ARCHITECTURAL REVIEW COMMITTEE MEMORANDUM

DATE: June 18, 2024 Unfinished Business

SUBJECT: A REQUEST BY SELENE PALM SPRINGS, LLC, SEEKING ARCHITECTURAL APPROVAL FOR THE FINAL DEVELOPMENT PLANS FOR THE NORTH AND SOUTH VILLAS RESIDENCES WITHIN THE DREAM HOTEL COMPLEX LOCATED AT THE NORTHWEST CORNER OF AVENIDA CABALLEROS AND AMADO ROAD; ZONE PDD 333, SECTION 14 (CASE 5.1132-PD 333 / TTM 35236) (ER).

PERIMETER TREATMENT

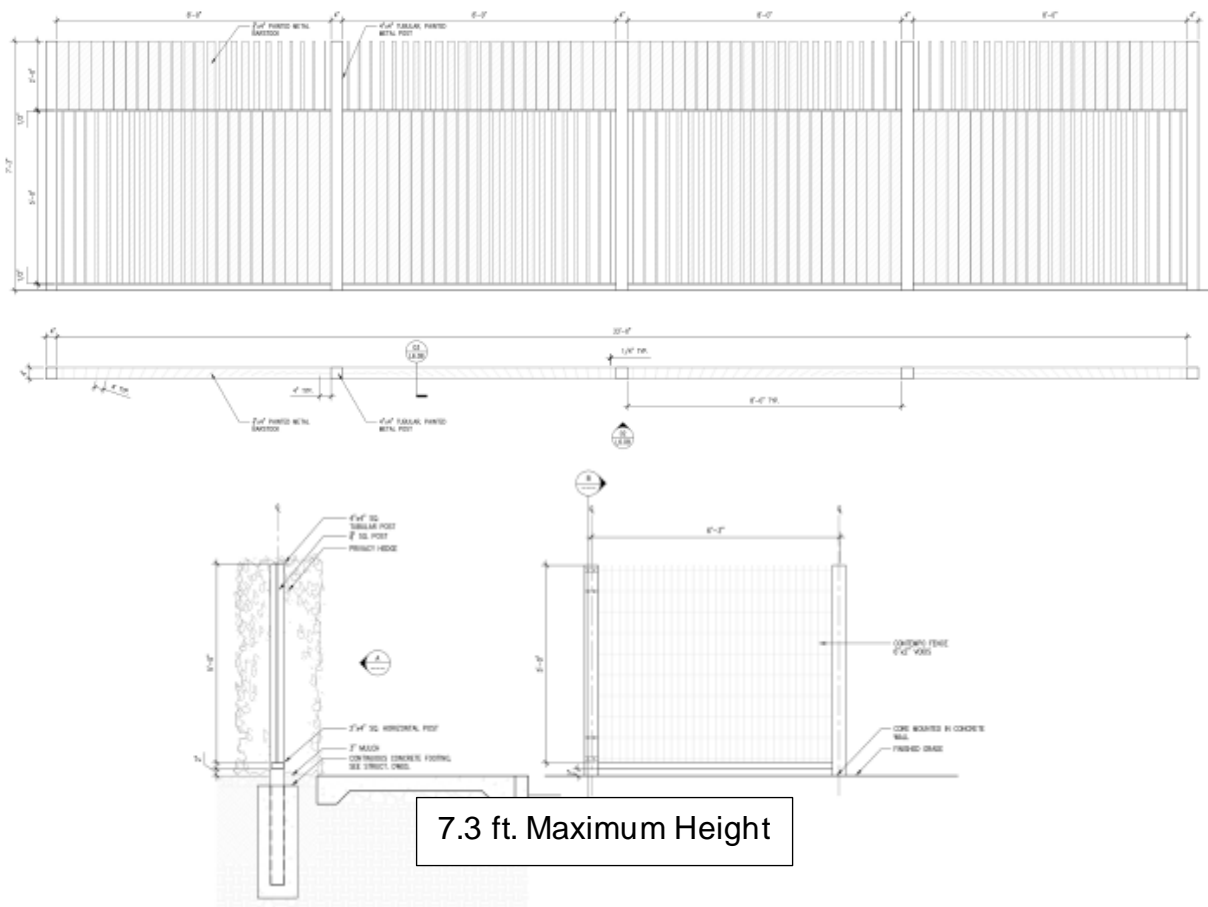
2. Lower the height of the perimeter poured-in-place concrete site walls to not more than 6 feet as measured on the public street side and relocate the walls further into

the site at least 5 feet, consistent with the zoning code, to better accommodate pedestrian movement and provide a more pleasant pedestrian experience along the public streets.

Response: As was expressed at the prior ARC with respect to site security considerations, the height of all perimeter site walls / screens has been reduced somewhat and now shown varying at either 7'-6" or 8'-0" from the adjacent grade. As regards the 5-foot wall setback, this is not necessary as the wall is already setback a minimum of 6 feet from the edge of the sidewalk. For reference, see Perimeter Treatment – Street Section A-A page 68.

Staff Response: The applicant has been advised that the overall site plan and the maximum height of the perimeter walls/fences shall be 7 feet, 3 inches, consistent with the City Council's previous approval of the amended project. The applicant was also informed that the materials for the perimeter treatment shall remain the same as the original Council approval. Below are the Council approved plans for the perimeter treatment.

7.3 ft. Maximum Height
